Docket Item # 10
BAR CASE # 2010-0268

BAR Meeting
October 20, 2010

ISSUE: New Construction

LOCATION: 1126-1128 Prince Street

Figure 3. Initial proposed front (north) elevation (10/6/10 BAR Hearing) highlighting areas to be restudied

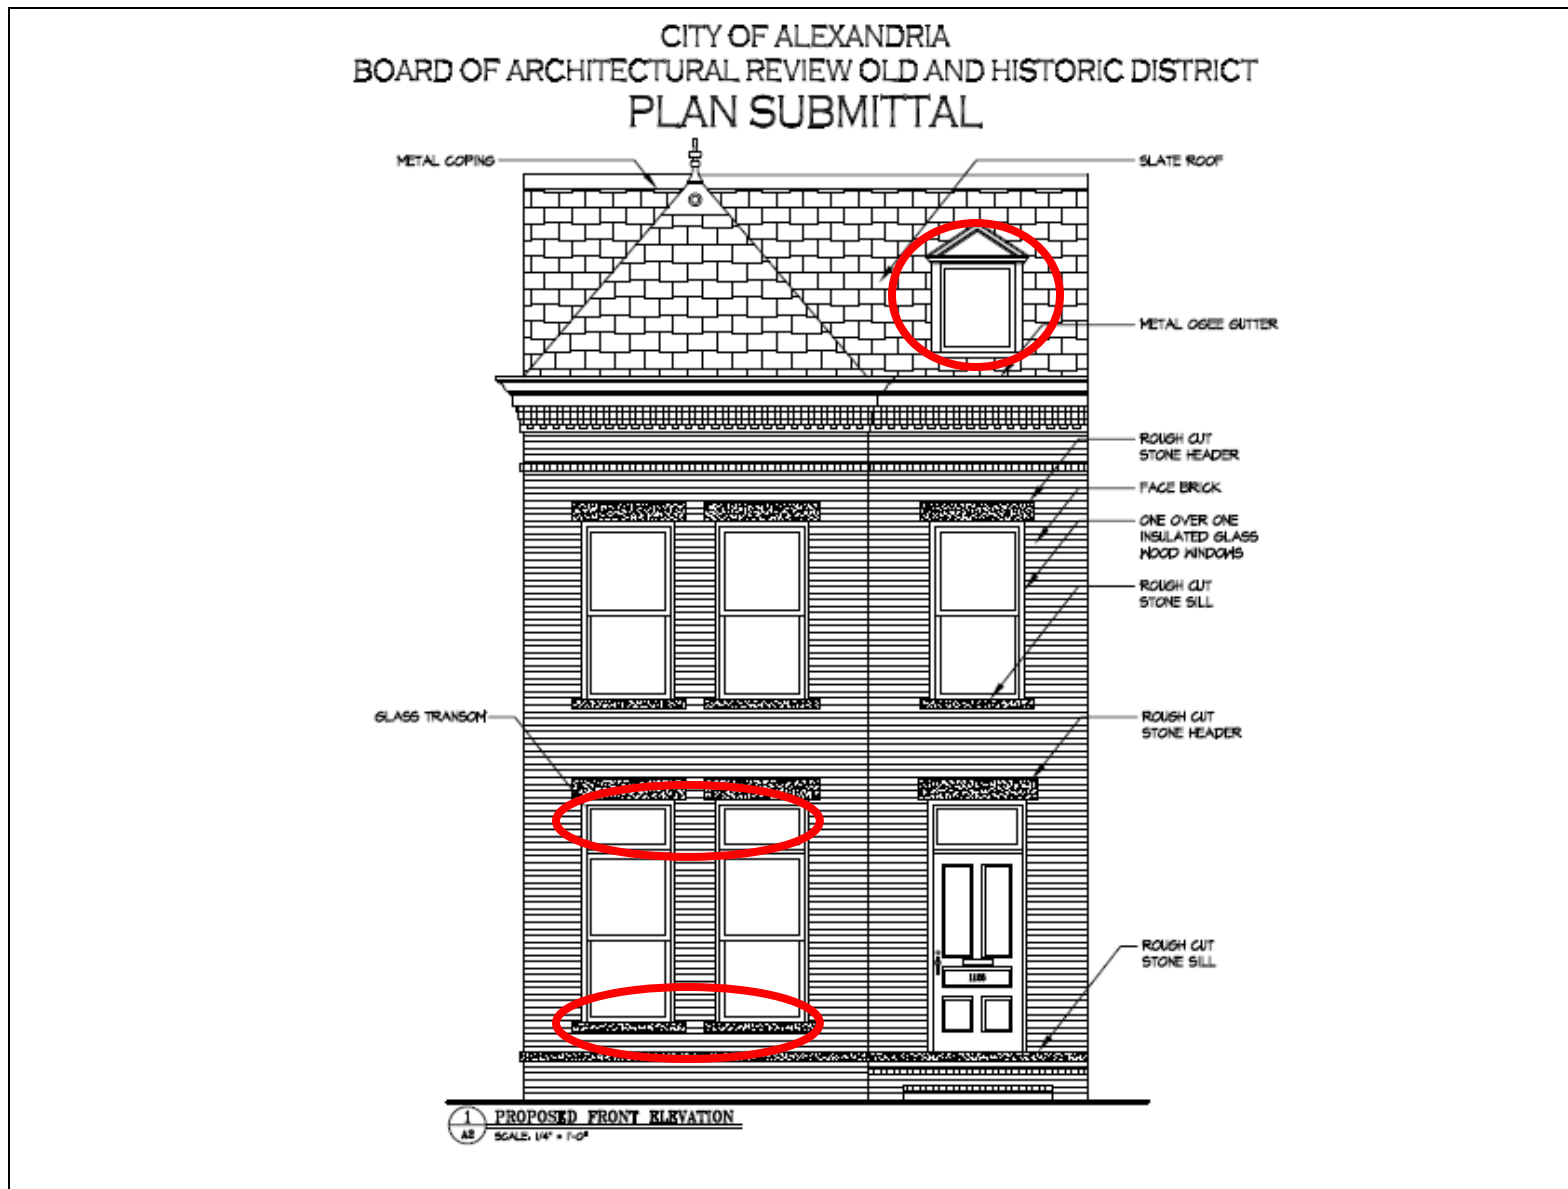
At the October 6, 2010 hearing, the Board unanimously voted to defer this case for restudy of elements on the front elevation. The Board recommended that the applicant restudy proportions on the front elevation: raising the first floor of the townhouse through the addition of basement windows and raising the sills on the first story windows. The Board also suggested eliminating the transoms on the first story windows. The Board recommended further study of the front dormer.

Figure 4. Revised front elevation with incorporated changes.

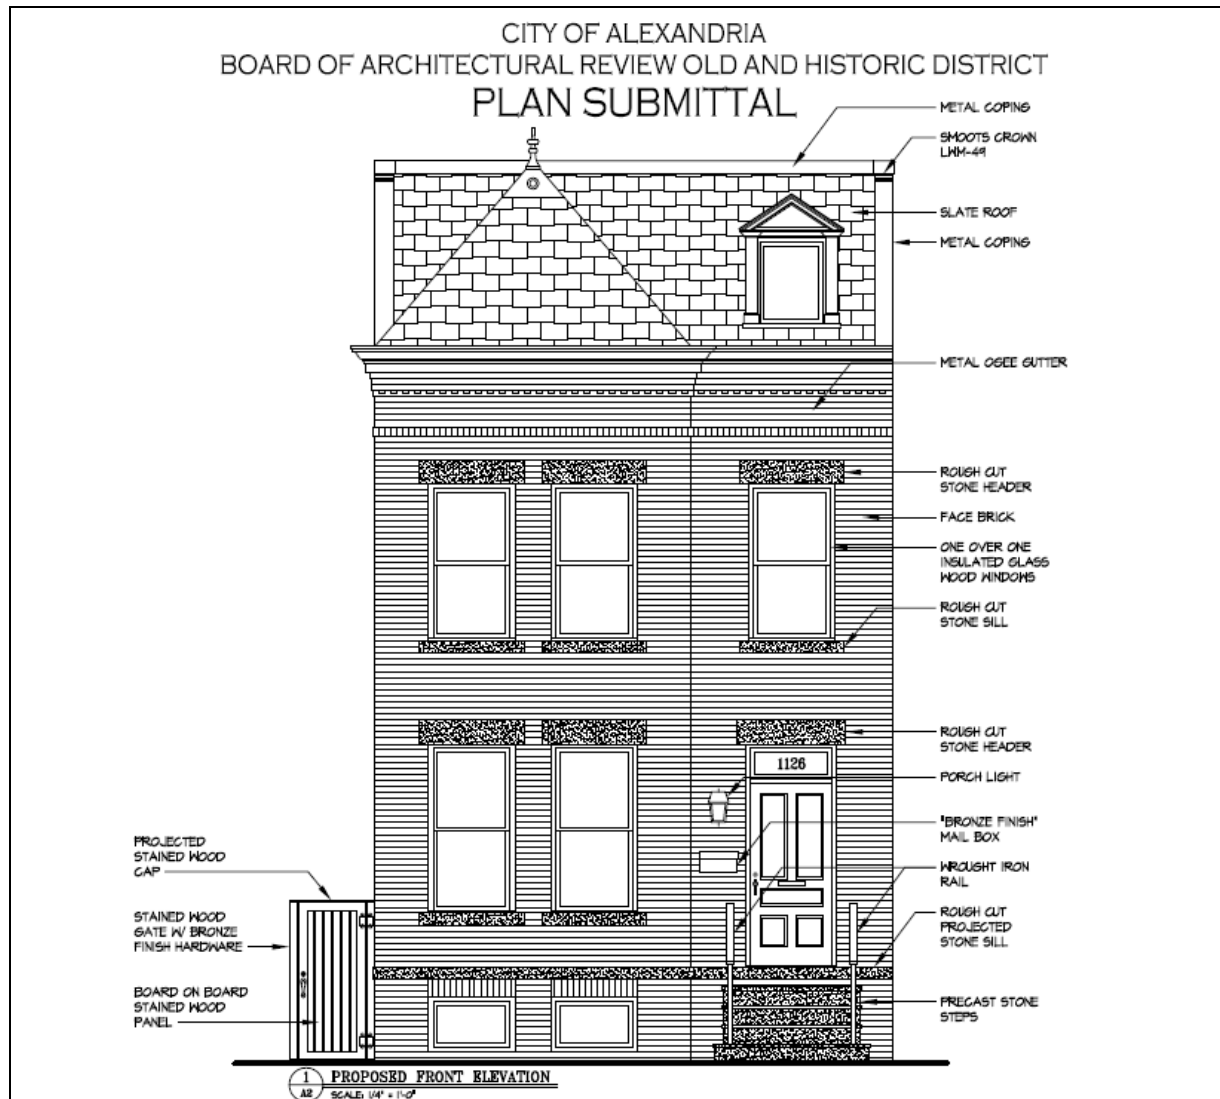
In response, the applicant resubmitted plans for the front elevation that addressed the Board's concerns. In response to an earlier Staff comment, the applicant further revised the front stoop to make it a more prominent feature and adjusted the slope of the roof to accommodate the increased height of the façade. Metal coping was also added to the roof.

Staff finds the revisions to be an improvement to the original design and has revised the analysis section below to incorporate the restudy.

The front (north) elevation will have two, one-over-one sash windows in each story of the projecting bay, with a single window above the front door. The door will have a transom. The proposed transoms above the first story windows have been removed. The applicant has added two basement awning windows with brick soldier-course headers. The front stoop will have a landing measuring approximately 7.3 feet by 3 feet and three stairs encroaching three feet into the public right-of-way. The stoop will have a wrought iron railing. At the roof, there will be a small dormer with classical detailing centered above the entry. The west elevation will share a party wall with the existing building at 1130 Prince Street. The brick wall on the east elevation will have no fenestration. The rear (south) elevation will have a projecting portion with French single light doors at the first story and paired windows with transoms above. The recessed area of the rear elevation will have two single windows with transoms, one at each story. A small wooden railing encloses the window well in this area.

Figure 5. Proposed side (west and east) and rear (south) elevations.

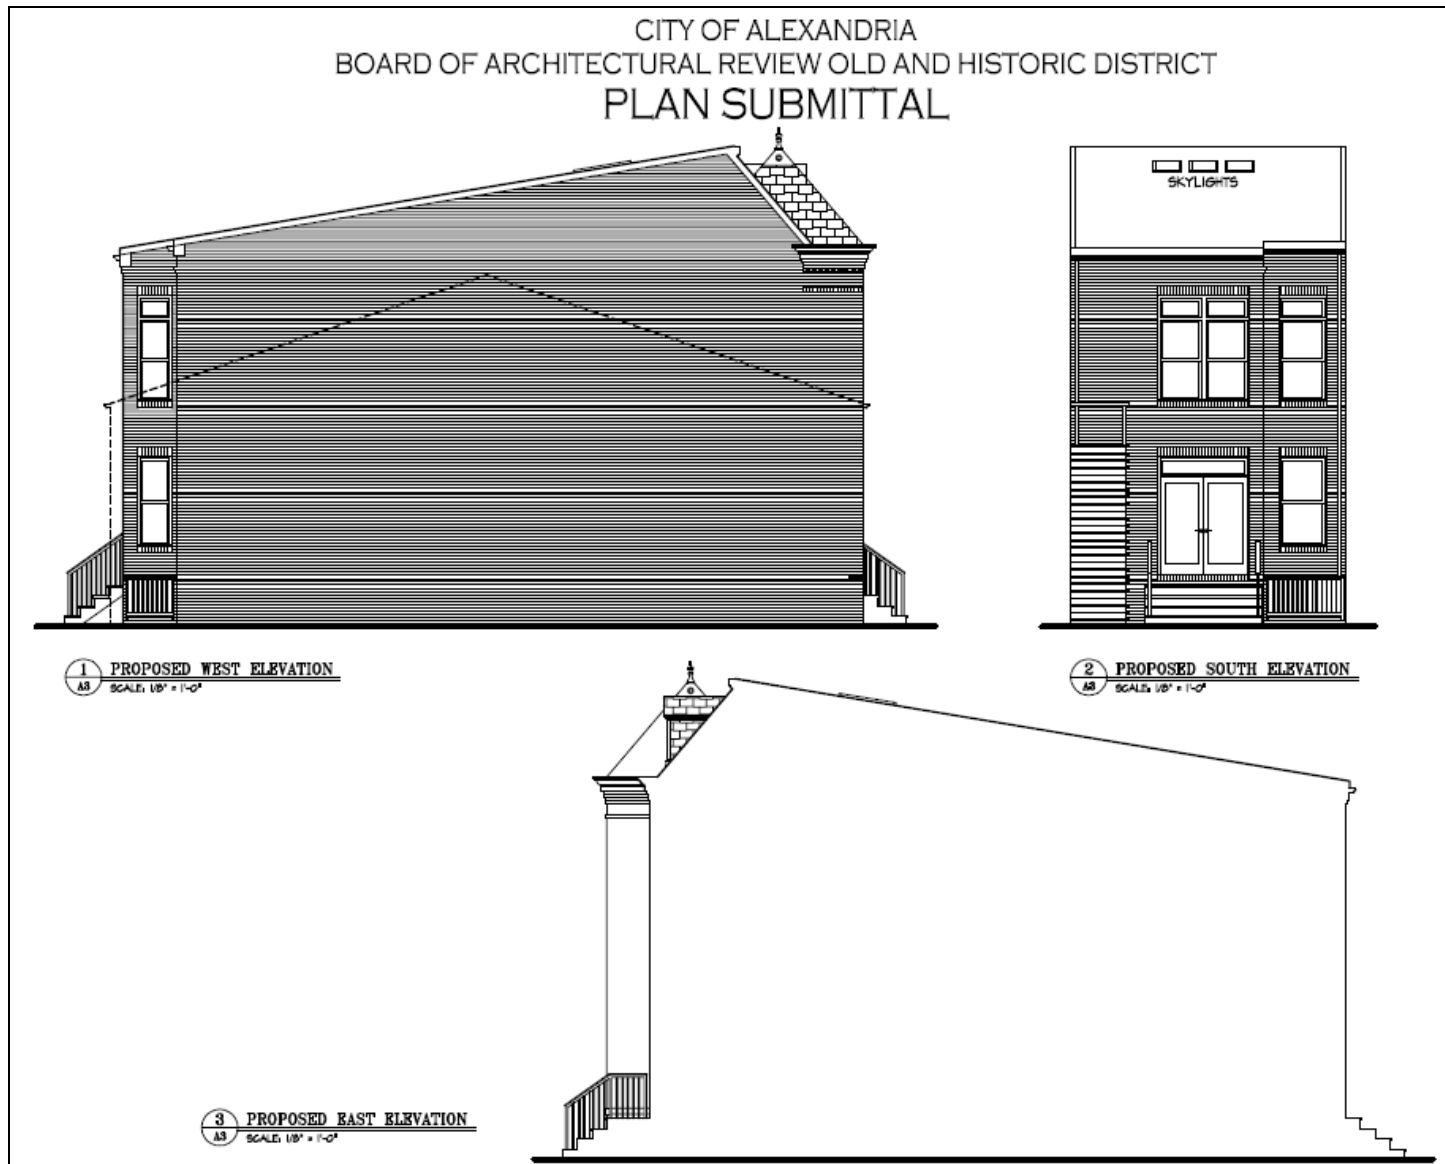
2. That the applicant locate the AC condenser unit on the subject property.
3. That a soldier course header be added above the doors and windows on the rear elevation.

The rear elevation of the townhouse will be visible from South Fayette Street. While the rear elevation does not have many characteristic late Victorian details, it is similar to the rear elevations of countless buildings throughout the district that have been altered or had rear additions. Staff had previously recommended that a soldier course brick header be added over the windows and doors on the rear elevation and the applicant has added this detail. The fire escape stairs that are shown are located on the corner parcel, 1130-1132 Prince Street. The applicant is proposing a shed roof on the rear portion with skylights which will not be visible. Staff recommends that a light-colored roof be used on the rear slope to minimize the urban heat island effect in support of the City's Green Building program.
